## TEXAS COMMISSION ON ENVIRONMENTAL QUALITY

Re: Edwards Aquifer, Comal County  
NAME OF PROJECT: McKenna Health Care M.O.B.; Located at the northeast corner of FM 311 and FM 3159; New Braunfels, Texas  
TYPE OF PLAN: Request for Approval of a Contributing Zone Plan (CZP); 30 Texas Administrative Code (TAC) Chapter 213 Subchapter B Edwards Aquifer  
Edwards Aquifer Protection Program File No. 2460.00  
Regulated Entity No. RN104860382  
Investigation No. 454089

# MCKENNA HEALTH CARE Contributing Zone Plan Phase 1 NEW BRAUNFELS, TEXAS, M.O.B.

**MCKENNA HEALTH CARE  
NEW BRAUNFELS, TEXAS, M.O.B.  
WATER QUALITY POND PLAN & DETAILS**

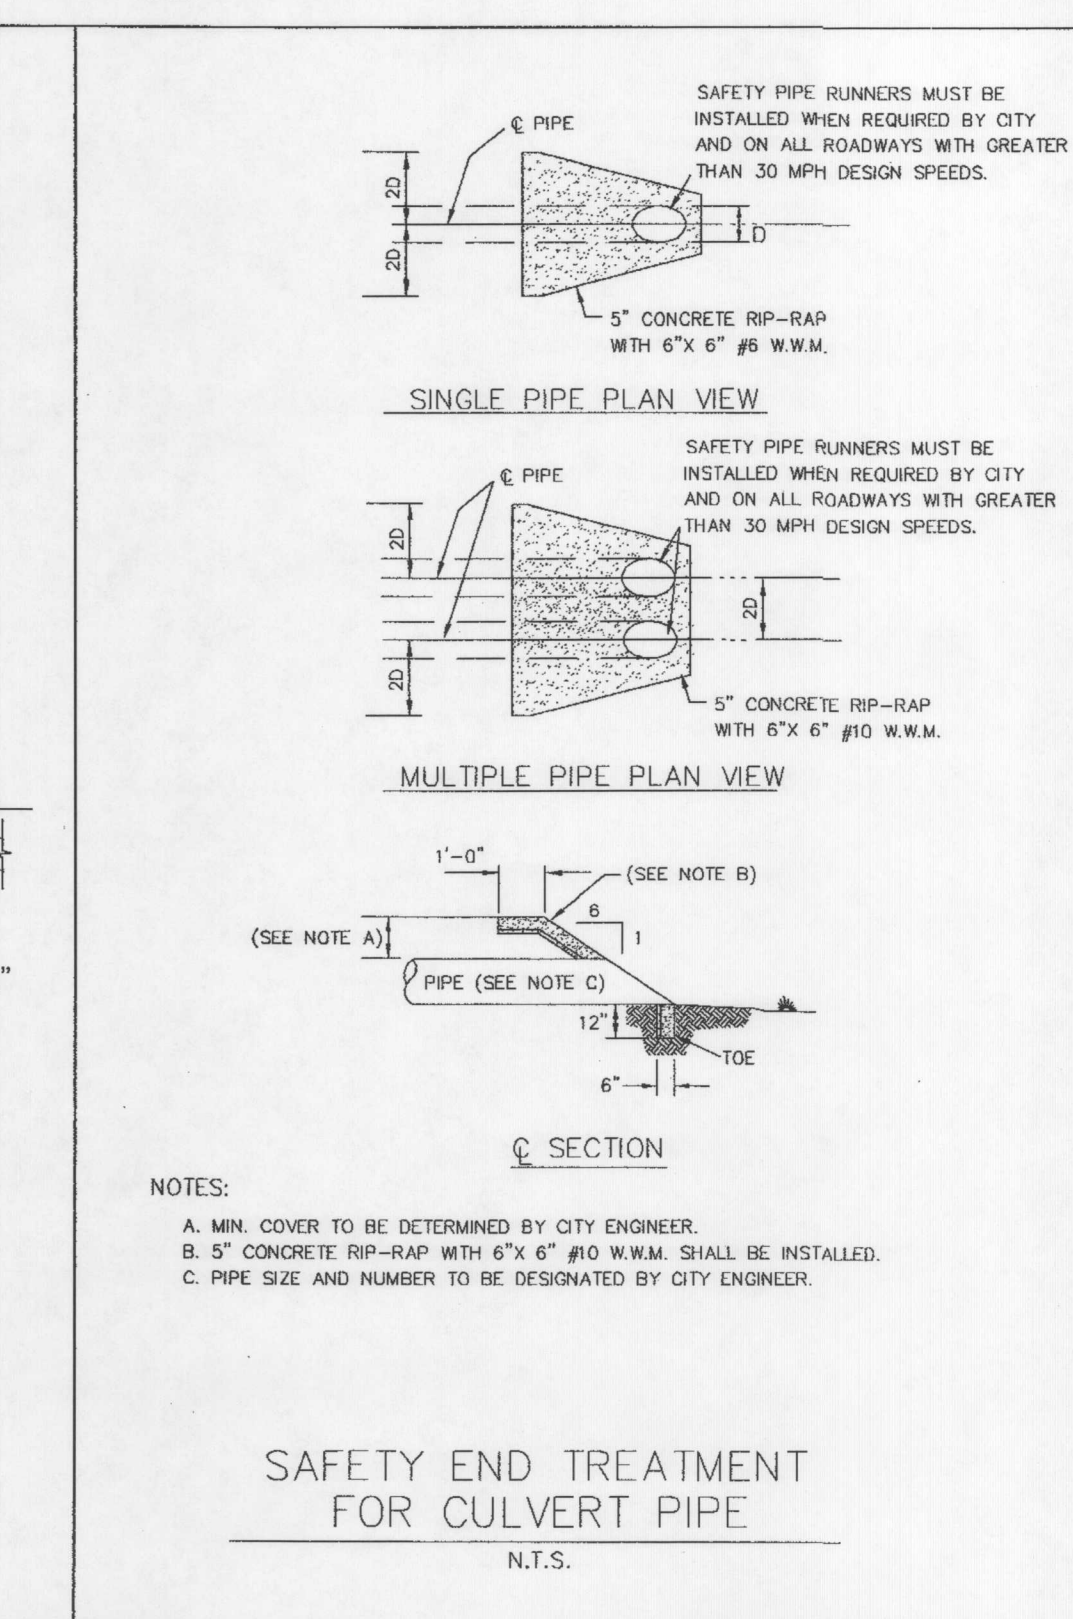
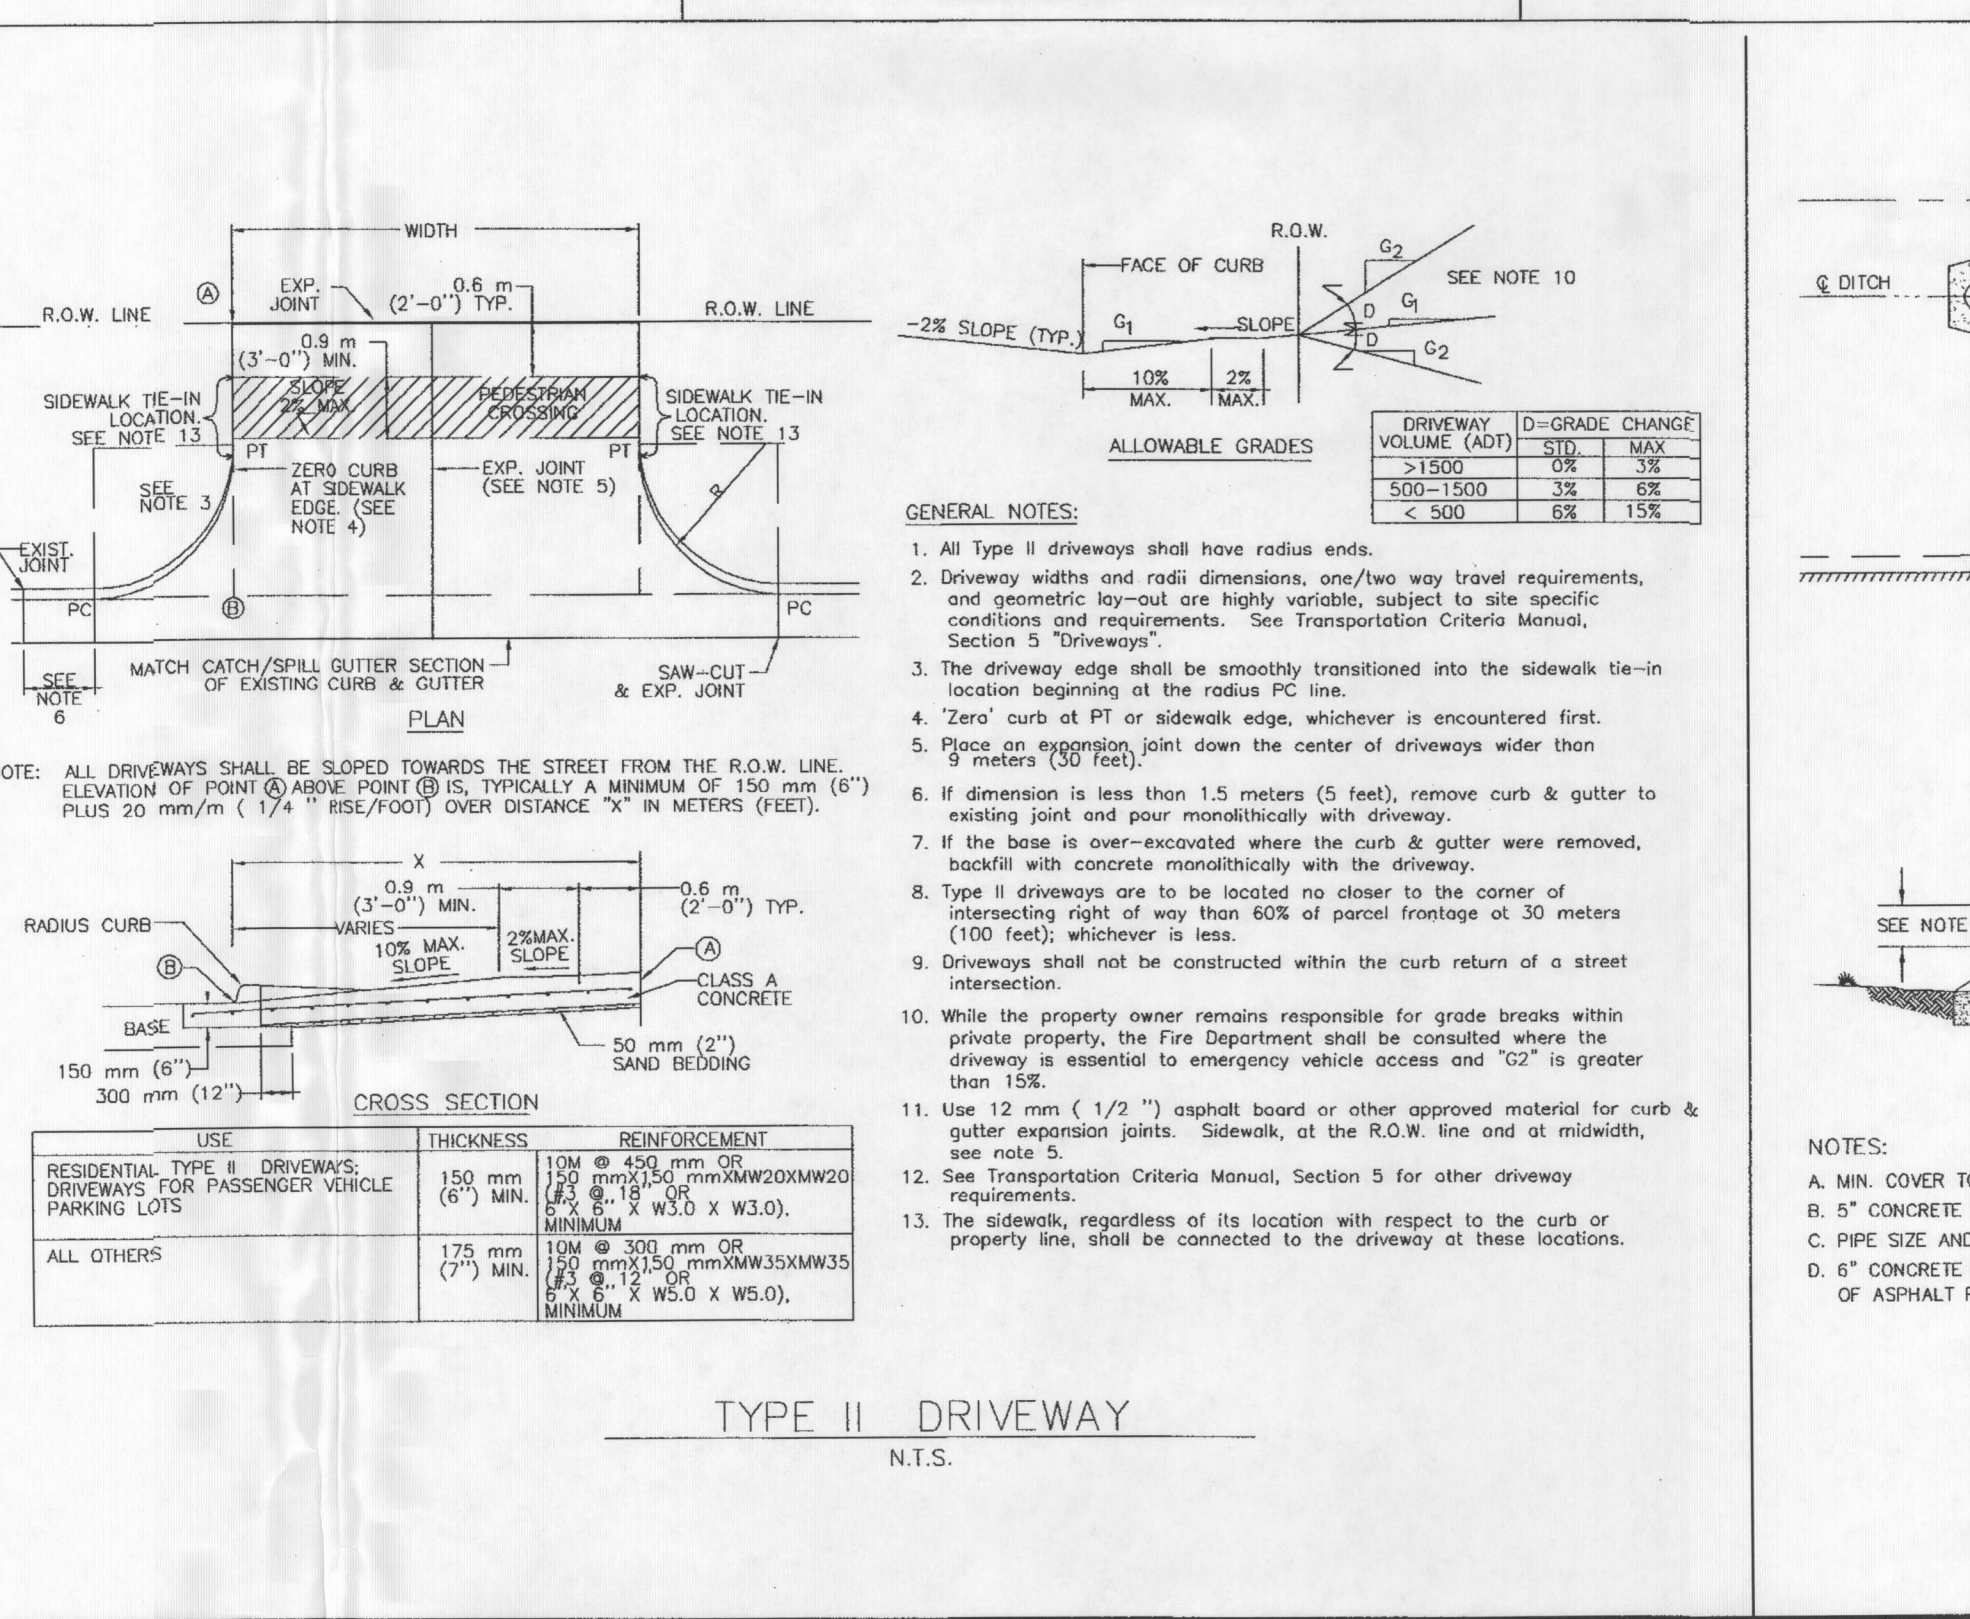
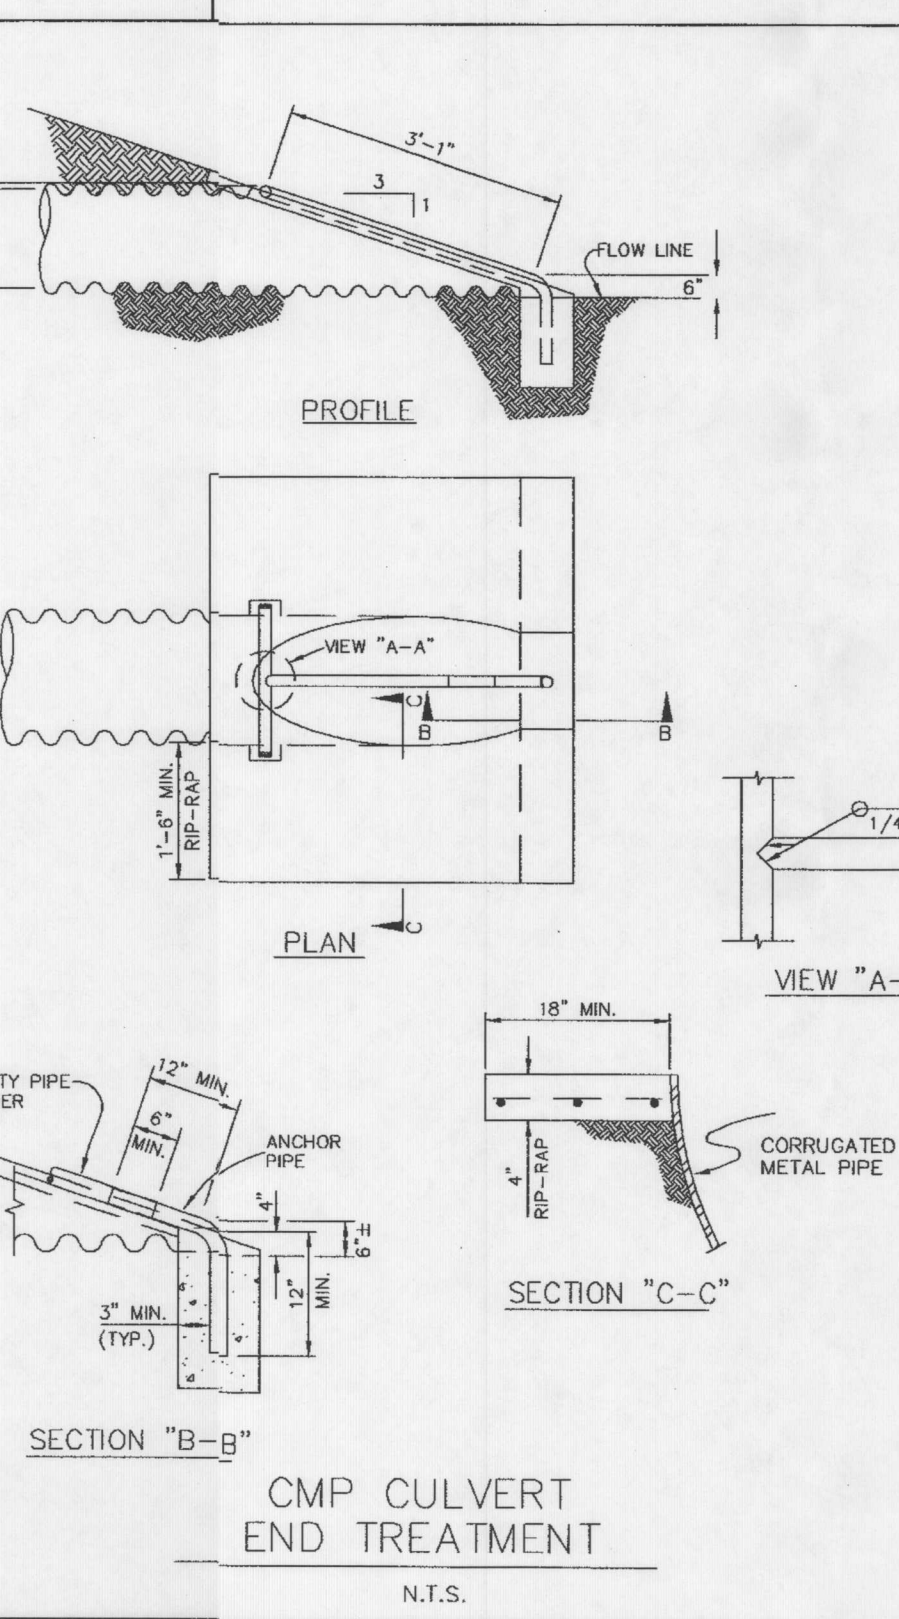
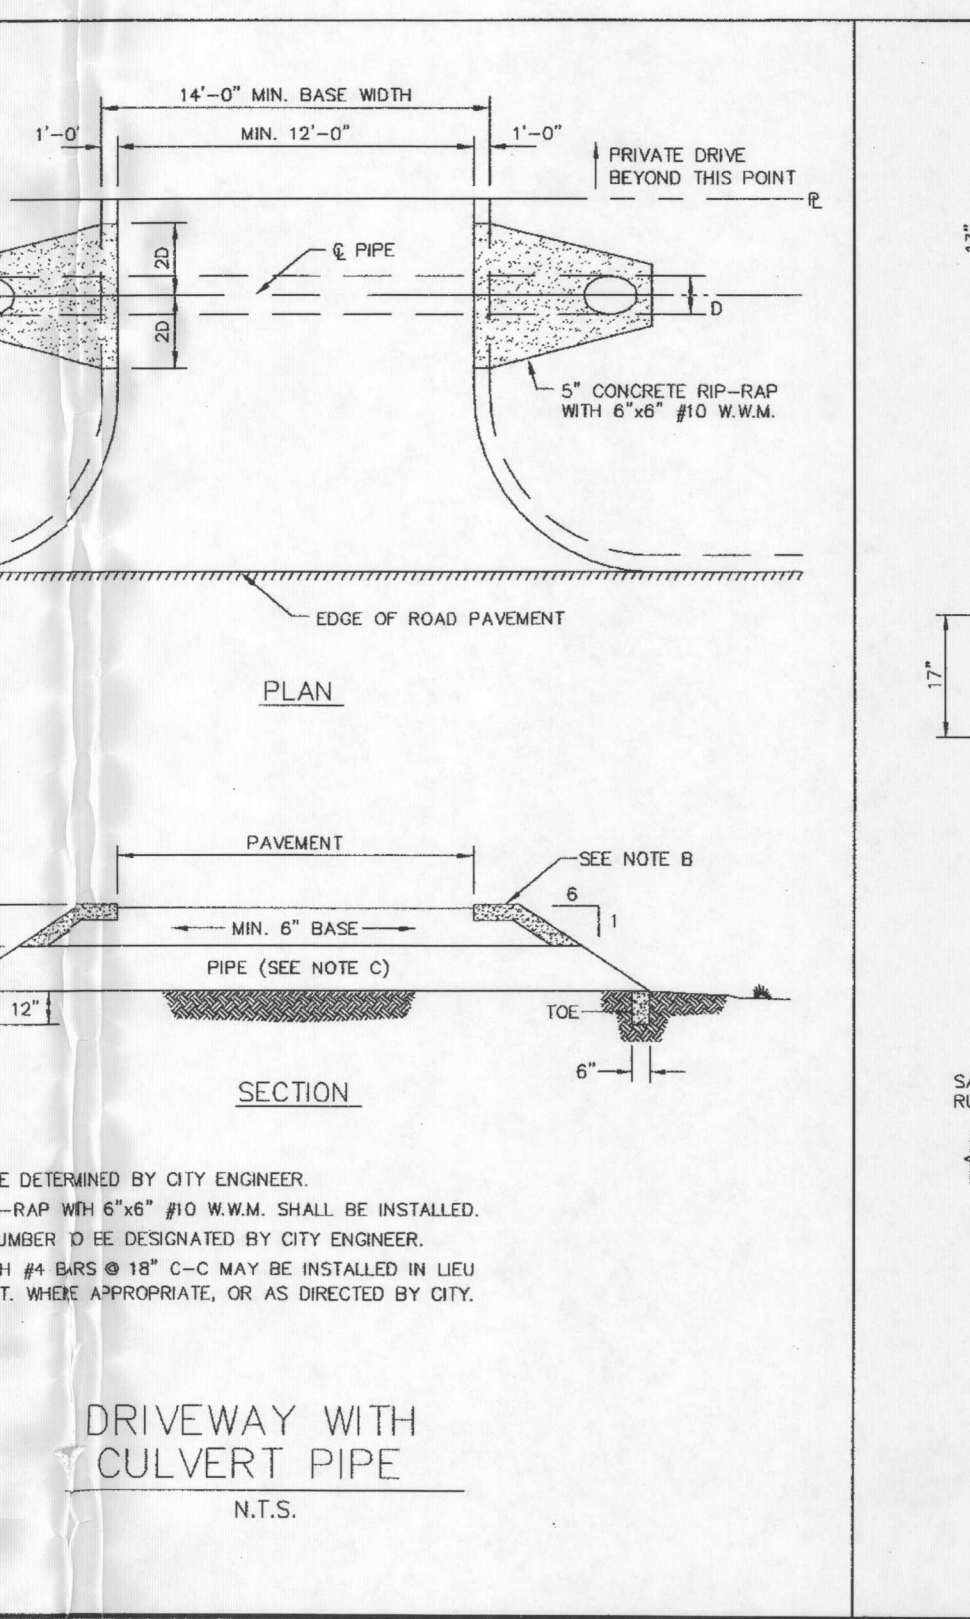
1. Detailed answers are provided for each question..
2. The pond has a design volume of 26,771 cubic feet which is in access of the required volume of 8,681 cubic feet per TCEQ spreadsheet. The pond will treat 1790.62 lbs of TSS per year. The sand filter area is 2,856 square feet in area. All these items are shown on sheet 7 of the plan set.

4. The following items are shown on sheet 7 of the plan set.
  - a. Flow line information is shown for underdrain piping at 1%.
  - b. Call out for maximum separation of 10' center to center is shown on sheet 7.

- c. Call out for screw on caps is labeled.
  - d. No basin liner is required this is a CZP plan not WPAP.
  - e. No basin liner is required this is a CZP plan not WPAP.

- f. Control access fence and gate are shown.
  - g. Access ramps to sedimentation and filtration basins are shown.
  - h. Staging area is shown.
  - i. Depth of water is 4' as indicated in spread sheet on sheet 7. WQ Elevation is 1274' and bottom of sedimentation pond is 1270'.
